**Monks Orchard Residents' Association  
Planning**

Location: 67 Orchard Avenue, CR0 7NE

LPA Application Ref: 22/03552/FUL

Appeal Ref: APP/L5240/W/23/3326869

**Interactive Spreadsheet calculating the difference between proposal Design Code and Post Code (CR0 7NE) Design Code**

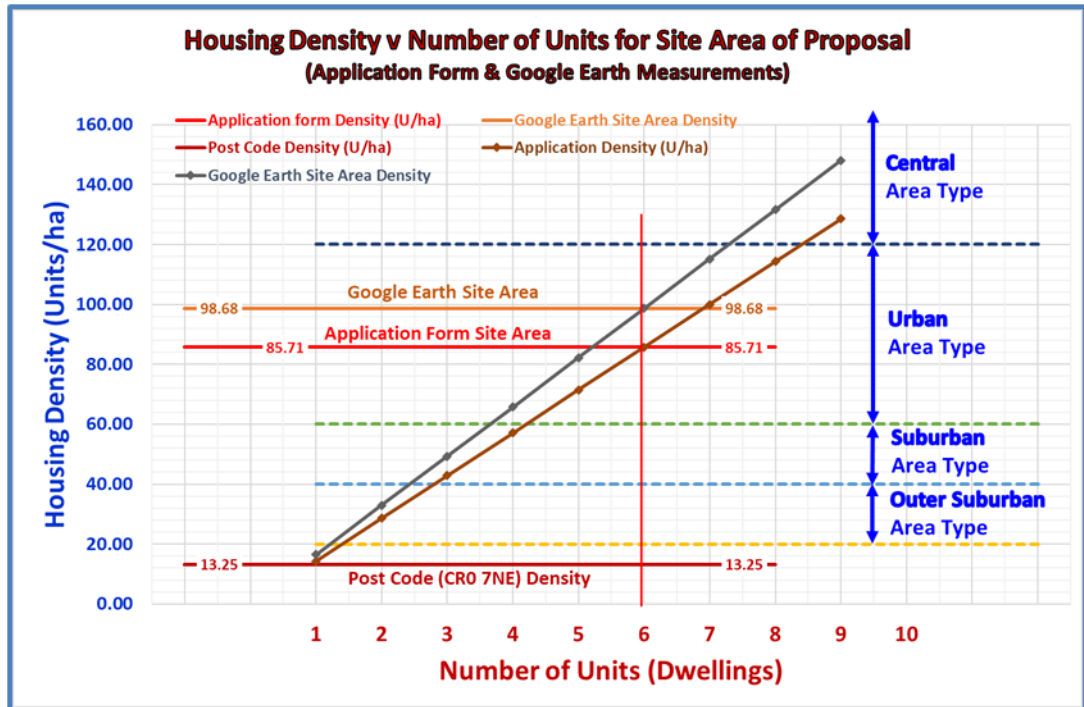
5.2.5.5 The assessment of the proposal's suitability for the locality is analysed by assessing and comparing the **Area Type Design Code** of the **proposal** with those of the **Local Area Type Design Code** of the **Post Code**. **As these are ratios of the same units, this is a valid comparison.**

5.2.5.6 **This assessment** places the **Post Code CR0 7NE** of **11 Units** in an area of **0.83hectarea** at **13.25Units/ha** which is an **Area Type <Outer Suburban** (less than), and the **Proposal** to be **85.71Units/ha** if the **Site Area** is **700sq.m.(0.07ha)** which is an **Urban Area Type** or **98.68Units/ha** if the **Site Area** is **607.77sq.m. (0.0608ha)** [*as measured by Google Earth*] which is also an **Urban Area Type**, and therefore **inappropriate** in an **<Outer Suburban Area Type** locality.

**Illustration of inappropriate Building Lines**

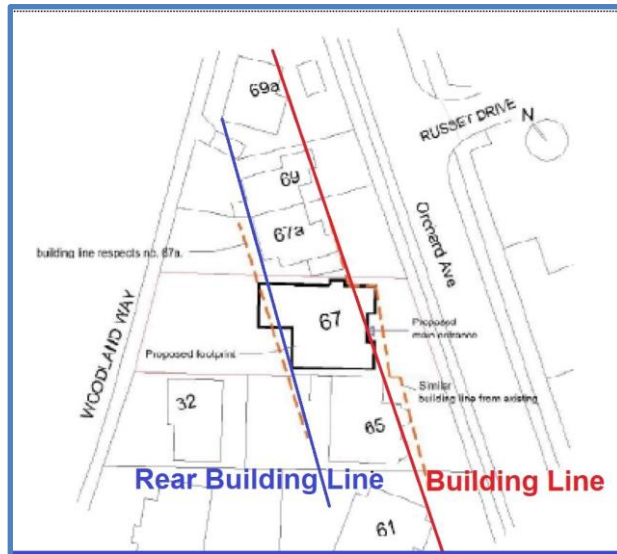
5.3.2.4 The proposal does **NOT** follow the existing established front Building Line of **Orchard Avenue**. The **Building Line 'Set-Back'** of the proposal at the Northern corner facing **Orchard Avenue** is **4.9m** whereas the **average** building line **'Set-Back'** of all dwellings along this part of **Orchard Avenue** has a **Building Line Set-Back of 6.5m** from the back of the footpath, which illustrates that the proposal is **1.6m** forward of the existing established **building line**.

5.3.2.5 The Proposal also does not follow the existing **rear Building Line**. The angular street views of the **Flank Walls** deliver a bulky impression and emphasises the **scale and massing, inappropriate** for the locality and the **Area Type setting**.
